SUNDRY NOTICES AND REPORTS ON WELLS
Do not use this form for proposals to drill or to re-enter an abandoned well. Use form 3160-3 (APD) for such proposals.

APACHE CORP REQUEST TO CHANGE TVD & MD FOR THE NFE FEDERAL #55H
FROM: TVD: 5525' MD: 11096'
TO: TVD: 5533' MD: 11152' Landing point: 5381'

NFE Federal

Plan: Plan #2 01-30-15

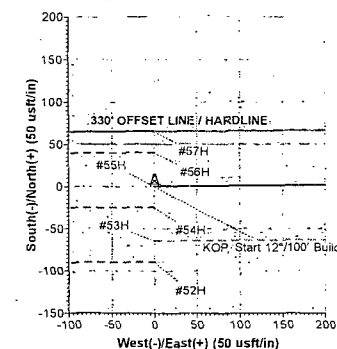
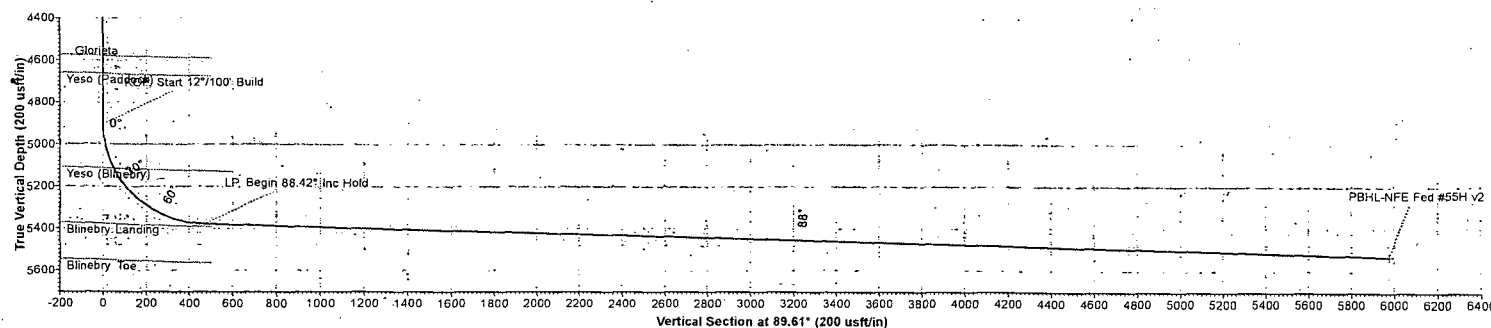
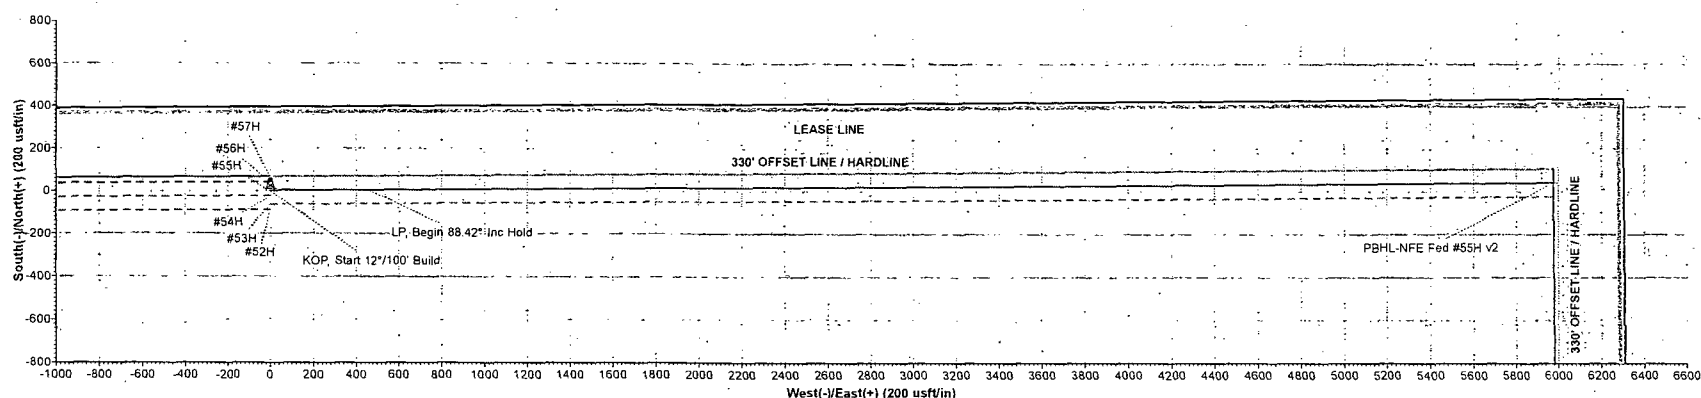
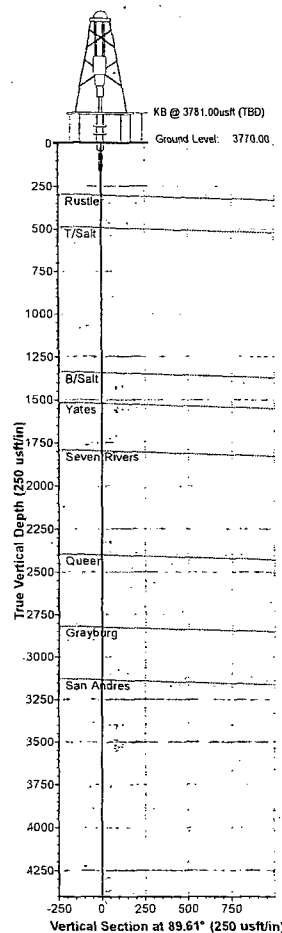
NEW DIRECTIONAL PLAN ATTACHED. NO OTHER CHANGE FROM ORIGINAL DRILLING PLAN.
